(54) **REFUSE CONTAINER**

UNITED STATES PATENT AND TRADEMARK OFFICE
CERTIFICATE OF CORRECTION

PATENT NO. : Des. 607,625 S
APPLICATION NO. : 29/331743
DATED : January 30, 2009
INVENTOR(S) : Richard Landry

FIG.6

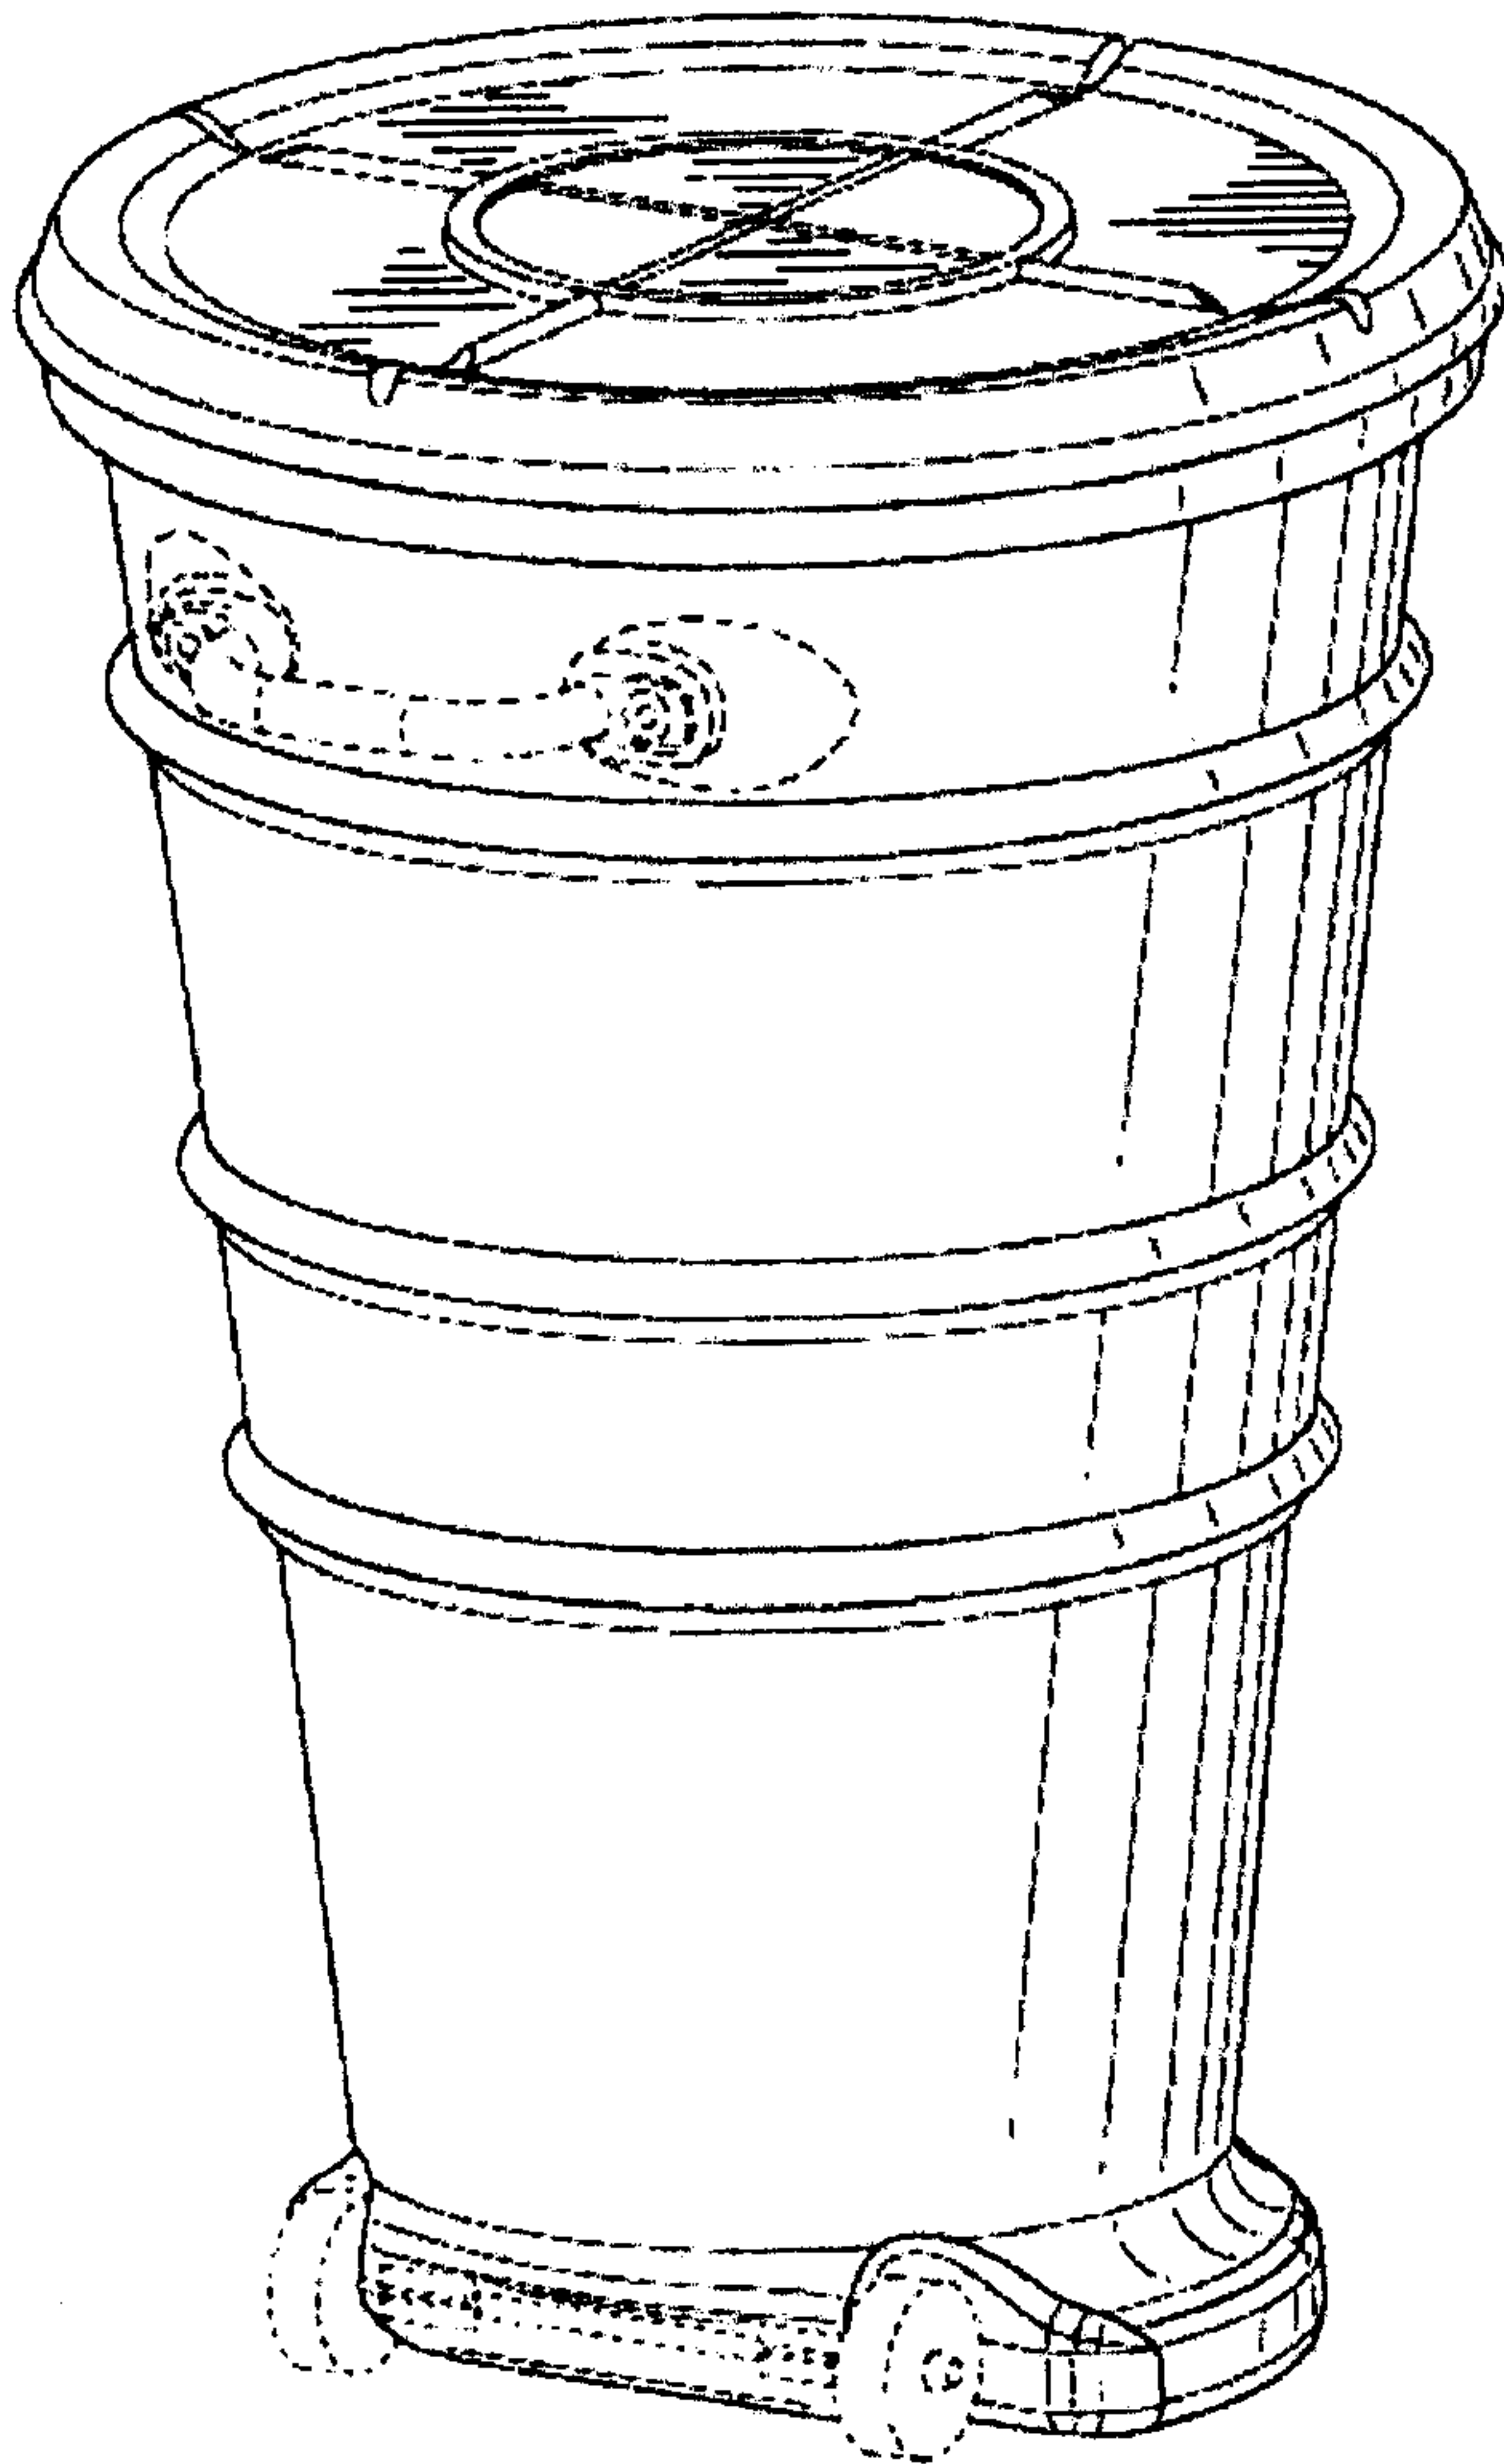
Description, between line 9 and line 10 insert the following
--FIG. 6 is a perspective view of the refuse container of FIG. 1.--

Drawing Sheet 6, consisting of FIG. 6, is to be added as shown on the attached page.
